In re Patent Application of:
BERGERON ET AL.
Serial No. 10/700,193
Filed: 11/03/2003

REMARKS

Scobey's figure 10

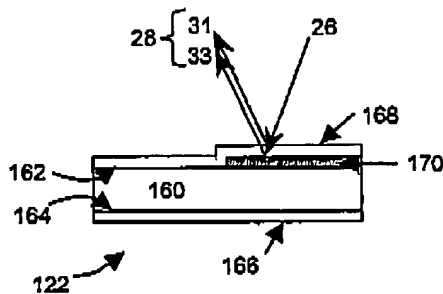
Referring to the two diagrams, shown below, Fig. 10 of Scobey et al. illustrates a reflector 170 located under the filter 168. (The same applies in Fig. 8 of Scobey et al.) In contrast, Applicants' reflector 170' is disposed "within" the multicavity filter rather than "under" it.

In Scobey's teaching his reflected beam 33 passes through all cavities of the multi-cavity filter, resulting in a significant time delay with beam 31.

The Instant invention

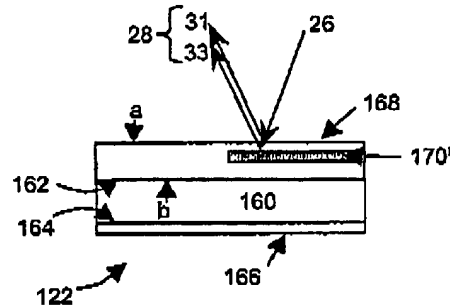
Instead of a reflective coating 170, the instant invention has a layer* 170' inserted inside the structure of the multi-cavity wavelength selective filter 168 (between "top" and "bottom" ends a and b of 168).

170' is inserted in a location that is sufficiently far from 'top' a of the multi-cavity filter structure as to ensure a proper phase match when first beam 26 is crossing between reflective and transmissive sections. [Location in terms of which cavity of the multi-cavity is 'decoupled'.]

At the same time, 170 is inserted in a location that is sufficiently close to "top" a to insure negligible time delay between reflected beams 31 and 33.

* = "A single layer with thickness other than a half wave, or integer multiple of a half wave", or any other alteration to one cavity of the multi-cavity filter that will decouple that cavity.

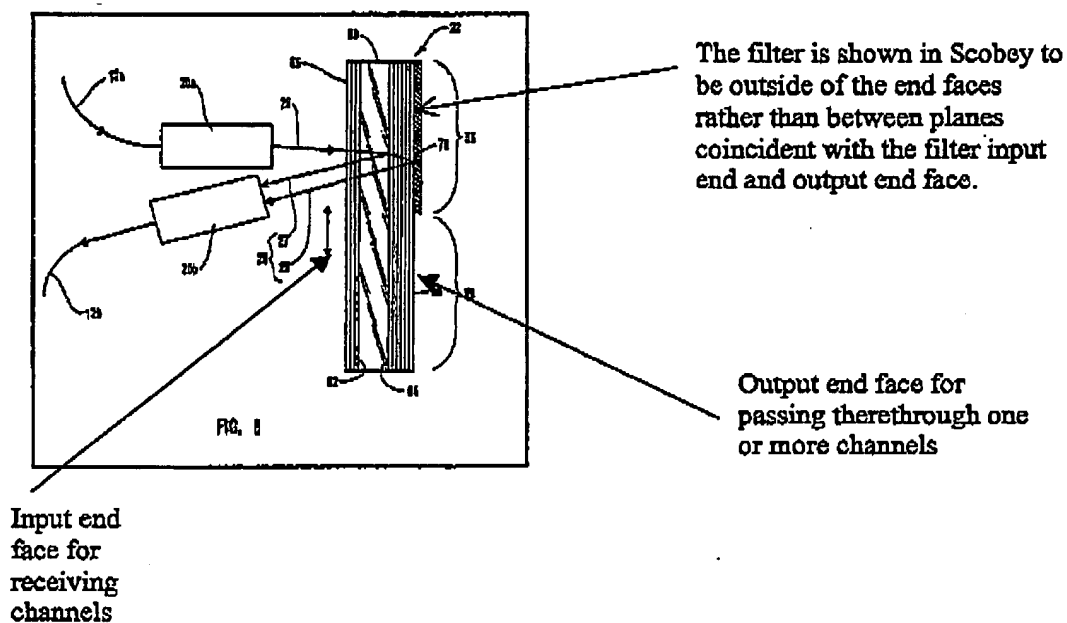
Claims 8 and 14 have also been amended to more clearly define the broadband reflector as being disposed between end faces of the filter, wherein the end faces are defined to be faces upon which light is launched into and out of the filter.

It is respectfully submitted that the amendatory language inserted into claims 8 and 14 delineates the fact that the broadband reflector is between the two end faces of the filter, in contrast to the invention of Scobey, wherein the

reflector is not between the two end faces, but is shown as being outside and against one of the end faces.
